UNITED STATES PATENT AND TRADEMARK OFFICE

10/596,847

Office Action Summary	Application No. 10/596,847	Applicant(s) MUSAEFENDIC, JASKO	
	Examiner JENNIFER STEELE	Art Unit 1794

DETAILED ACTION

FIG. -1

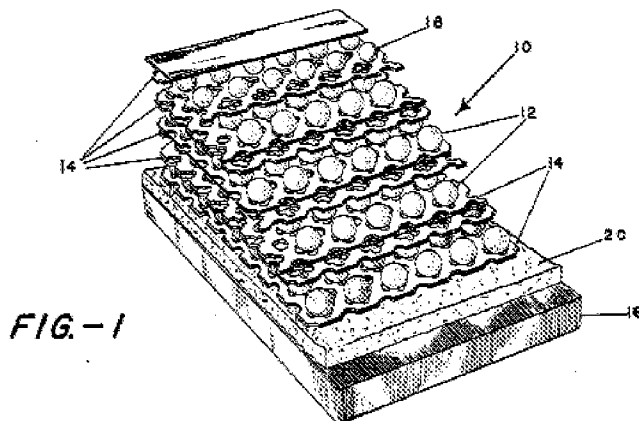
Cook teaches a multiply ballistic armor system comprised of layers of hard geometric objects tensionally restrained in their layers by fiber material interwoven about the objects and the objects and fibers are bonded together by adhesive (ABST).

See Fig. 1 and 4 below.

Each layer of geometric objects is equated with a ply layer. Cook teaches multiply inner plies.

As to claim 64, Bjorksten differs and does not teach reinforcing plies made from the materials claimed. Cook teaches the geometric objects are tensioned together with fiber strands. The fiber strands are interwoven around so as to support each rod **70** in tension against impact (col. 6, lines 1-15). The fiber strands, shown in Fig. 4 as **76** are equated with Applicants claimed single fibre reinforcement and/or woven rovings.

FIG-4

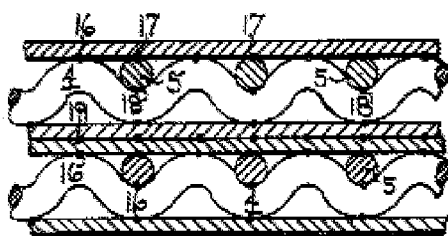
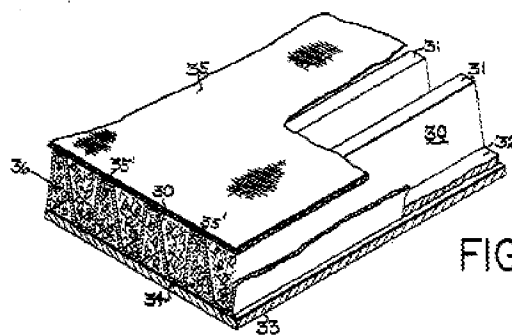
Hollis teaches a protective wall structure that resists penetration and impact. Hollis teaches outer layers of multilayer cloth with at least one inner protective inner layer defined by a rib-like formation defining a series of pockets. The pockets are filled with a polymer self sealing core structure (ABST). The polymer is equated with Applicant's polymer matrix. The structure of Hollis is shown in embodiments in Fig. 4 and Fig. 8 below.

As to claim 68, Bjorksten differs and does not teach a polymer matrix formed from one of the claimed compounds. Hollis teaches the polymer matrix which fills the voids can be of a epoxy-urethane elastomer (col. 10, lines 25-28).

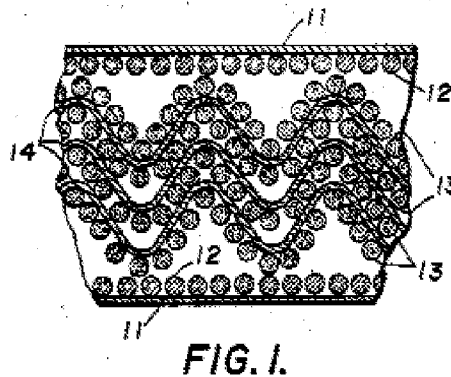
As to claim 67, Bjorksten shows an arrangement of dissipating ply elements that are in a unidirectional, cross-ply and symmetric, balanced as shown in the Figure above.

As to claim 71, Bjorksten teaches the laminate is created to dissipate force in a parallel direction (col. 1, lines 65-72). The dissipation of force in the laminate of Bjorksten is equated with Applicant's claim 71 where the loading is redistributed in a longitudinal direction to the main axis of said reinforcement plies.

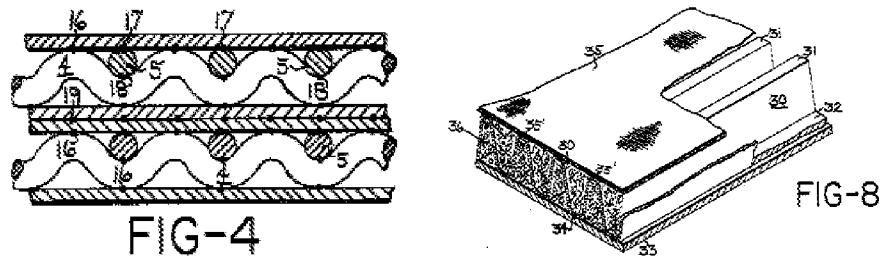
layer defined by a rib-like formation defining a series of pockets. The pockets are filled with a polymer self sealing core structure (ABST). The polymer is equated with Applicant's polymer matrix. The structure of Hollis is shown in embodiments in Fig. 4 and Fig. 8 below.

It would have been obvious to employ the polymer resin filled pockets of Hollis in the high impact laminate of Calfee motivated to increase the strength of the composite laminate.
